ADDENDUM NO. 1 | JUNE 9, 2016

DRINKING WATER REVOLVING LOAN FUND
WATERLINE REPLACEMENT PROJECT 1.3

A/E PROJECT NO. 20-1518
PROJECT NO. DWRLF-1003

ST. BERNARD PARISH
OWNER

TITLE SHEET
ST. BERNARD WATERLINE REPLACEMENTS
ST. BERNARD PARISH, LOUISIANA

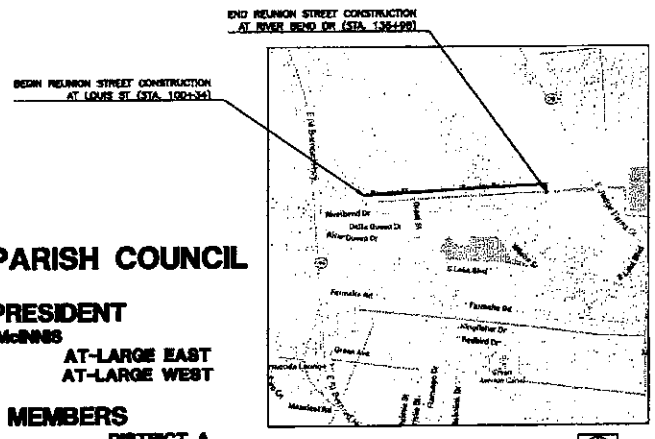
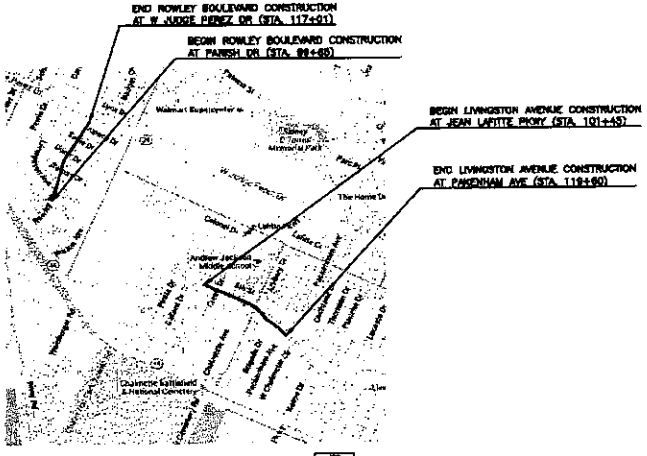
AD1.12 Drawings, Sheet No. 1, Title Sheet, Delete Sheet No. 1 in its entirety. Replace with Exhibit 2 numbered AD1-20.
